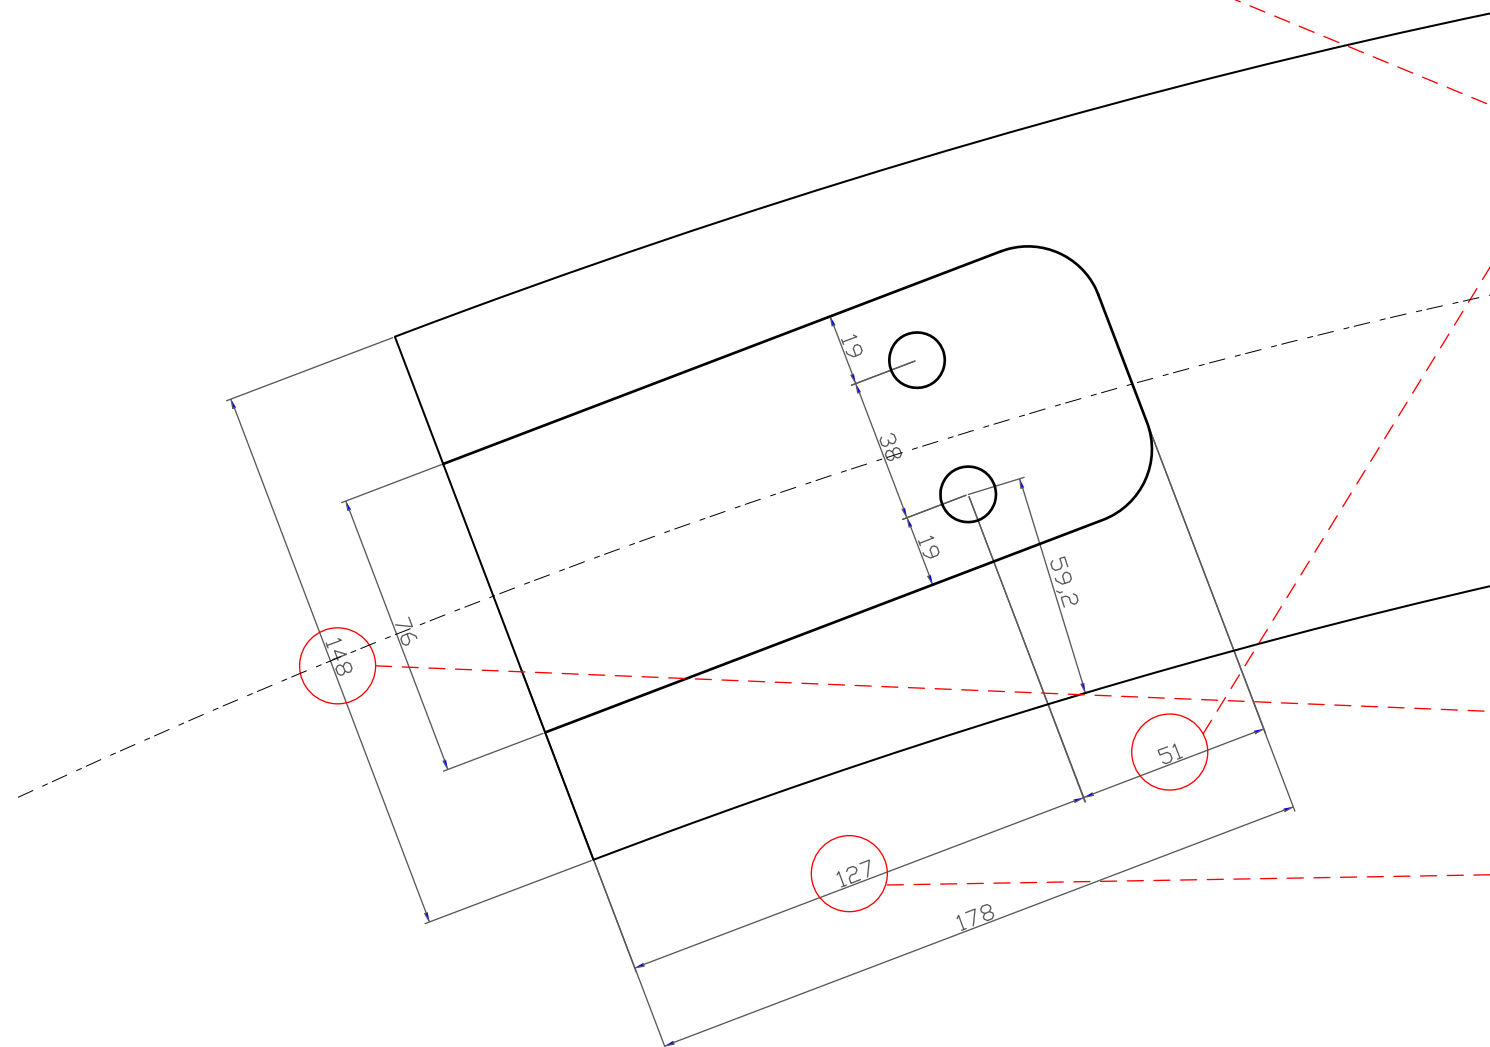
On page 1 in the document you sent us, there is a dimension of 88mm (located in the bottom center of the page). To what does it refer?

Bolt diameters = 14.7mm (12.7mm bolt size + 2mm)

Are these dimensions correct?

The ribs are currently scripted at a constant width of 148mm. Preferably, we would like it to remain as such instead of varying the width. Is this possible or would dead weight be an issue?

This dimension seems quite large, is there any way to reduce it?
